THE MARYLAND-NATIONAL CAPITAL PARK AND PLANNING COMMISSION

MCPB  
2/28/02  
Item No. 13

SUBJECT: MD 355/Montrose Road/Randolph Road  
Intersection Improvement Study Recommendation  
(Project MO830A11)

**RECOMMENDATION: Transmit the following comments to the Maryland State Highway Administration (SHA)**

# Exhibit 4 Schematic of Montrose Parkway Connections

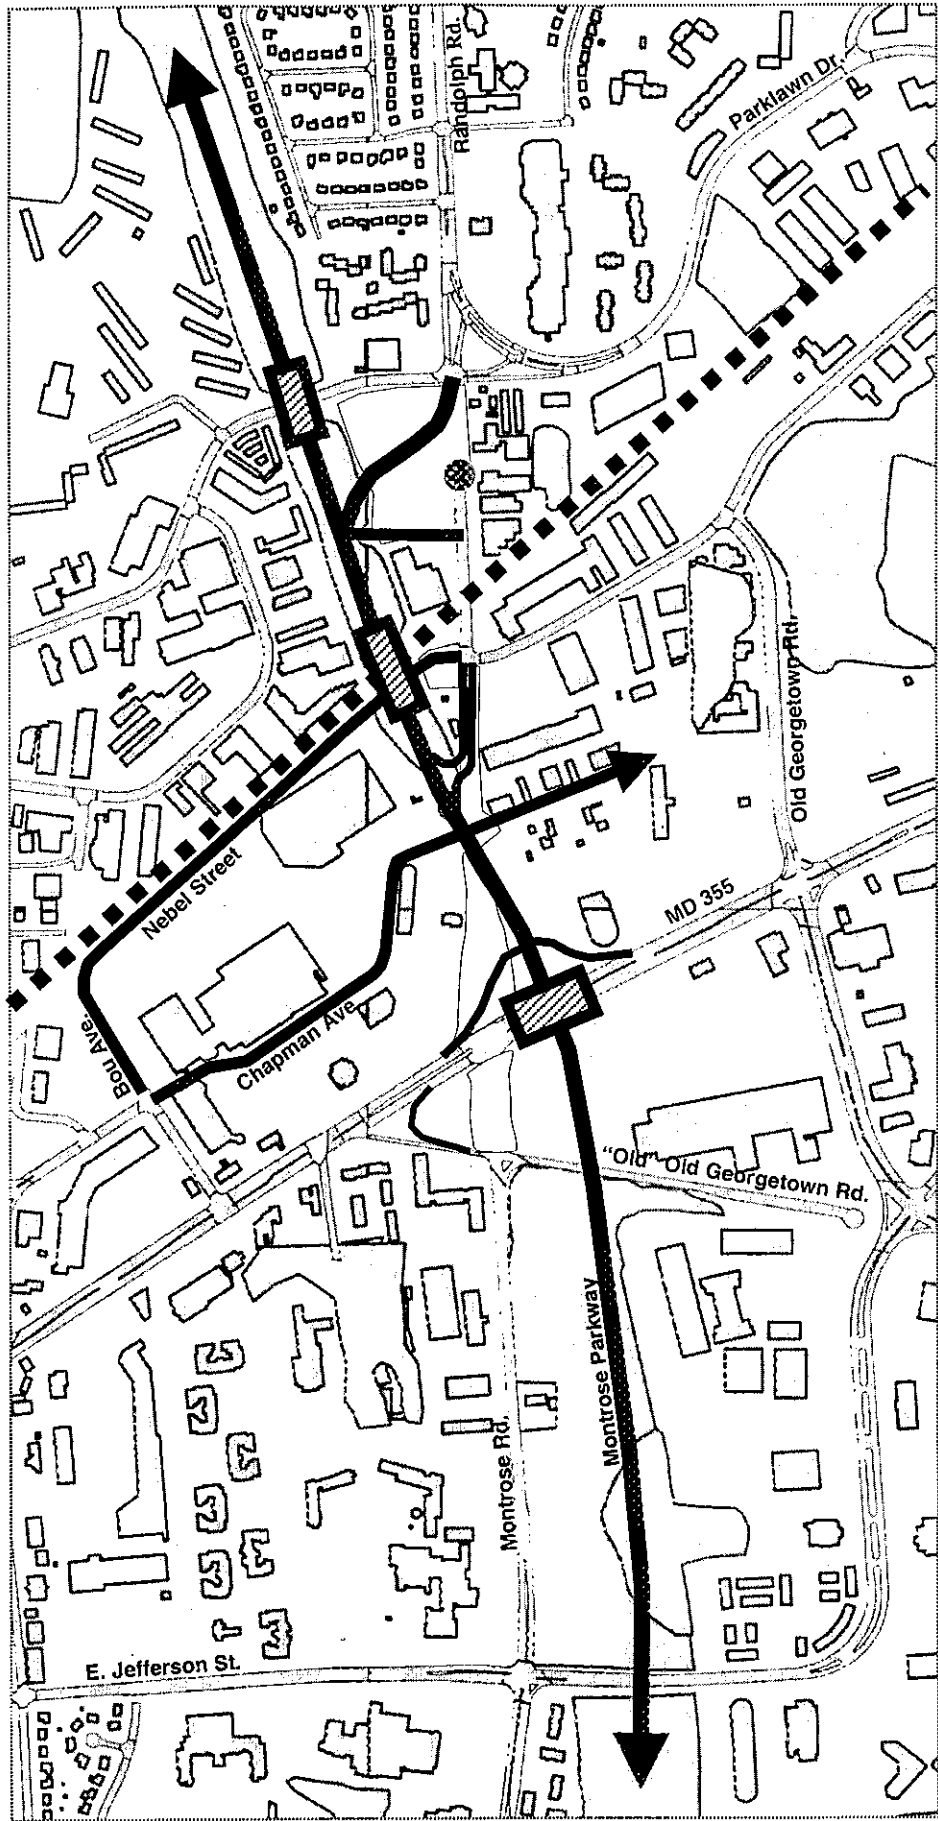
At the western end of SHA's project, staff believes this seamless connection will be achieved by connecting SHA's project directly to the County's Montrose Parkway project and terminating the existing Montrose Road at a "T" intersection with "Old" Old Georgetown Road, as shown in Exhibit 4. Staff recommends that the further SHA engineering efforts on Alternate 9 proceed with the Montrose Parkway connection rather than the Montrose Road connection shown in Attachment D.

Staff recommends that during the detailed design phases, SHA and DPWT develop designs that establish a common road grade, cross-section, and other design features for SHA's project to connect directly to Montrose Parkway West. This design should be included in SHA's project mandatory referral submission.

Staff understands that SHA will likely need to continue to design an option for Alternate 9 that connects to Montrose Road (as shown in Attachment D), in the event that budgetary constraints or maintenance of traffic considerations allow SHA's project to precede the Montrose Parkway West project at their common terminus.

### **Option B-1 Modified**

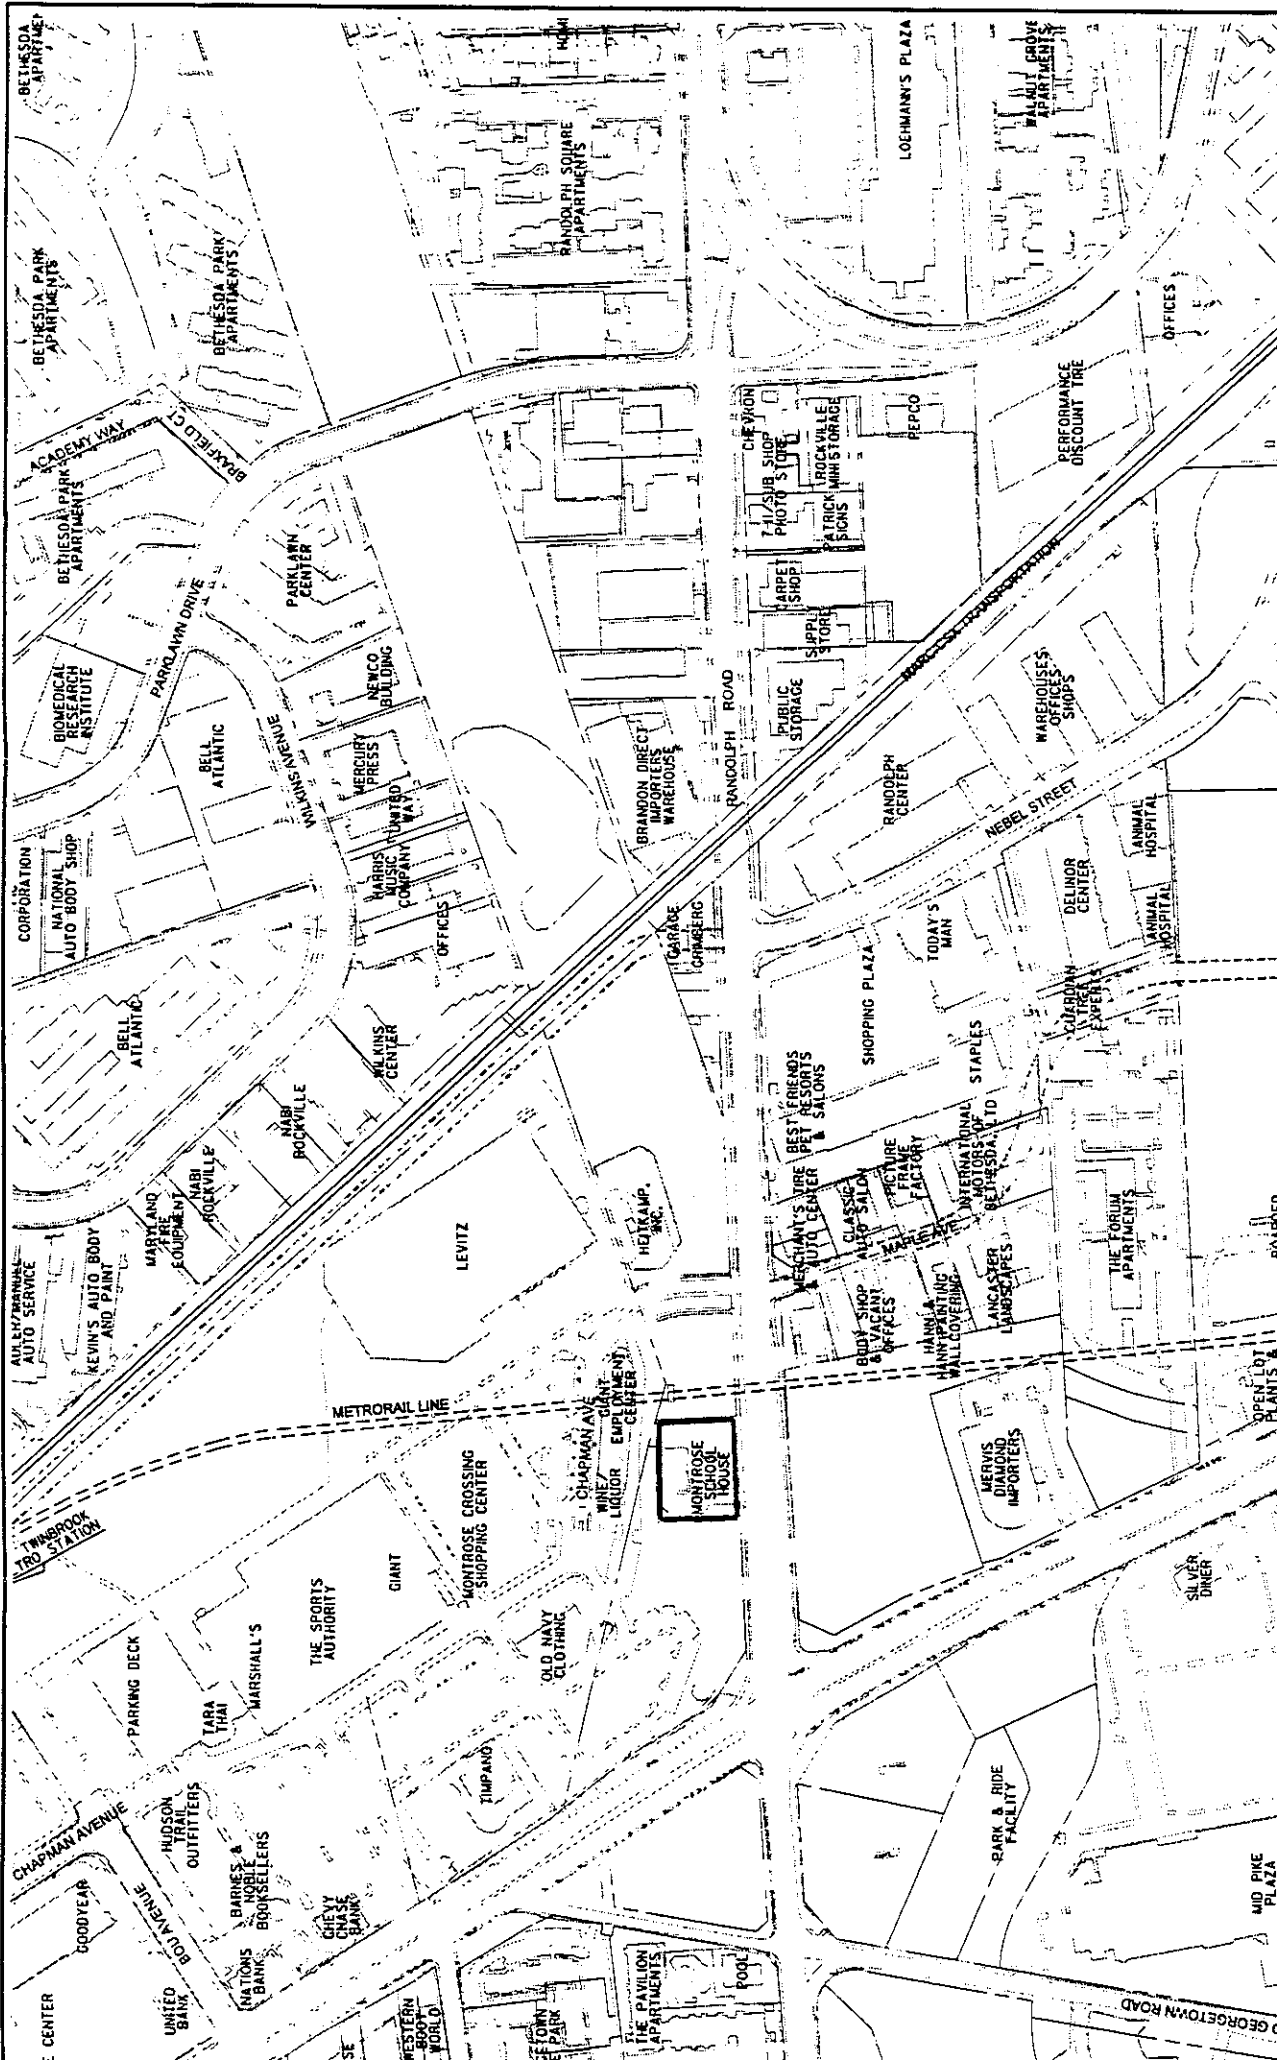
Staff recommends implementing Option B-1 Modified because it:

- Provides increased vehicular and pedestrian accessibility within the study area, and
- Reduces the traffic volumes crossing the CSX railroad tracks at-grade

The term "modified" in Option B-1 Modified refers to a connection between existing Randolph Road and relocated Randolph Road between Chapman Avenue and Nebel Street. This modification improves access to properties located south of relocated Randolph Road, replacing a proposed cul-de-sac on existing Randolph Road. Option B-1 Modified extends the west leg of a future four-leg intersection of Randolph Road and Nebel Street. Traffic could access this west leg from eastbound relocated Randolph Road near the Chapman Avenue intersection. Traffic heading away from the Randolph Road/Nebel Street intersection on the west leg would travel on a loop ramp connecting to eastbound relocated Randolph Road. An acceleration lane would be provided across the bridge over the CSX track between Randolph Road.
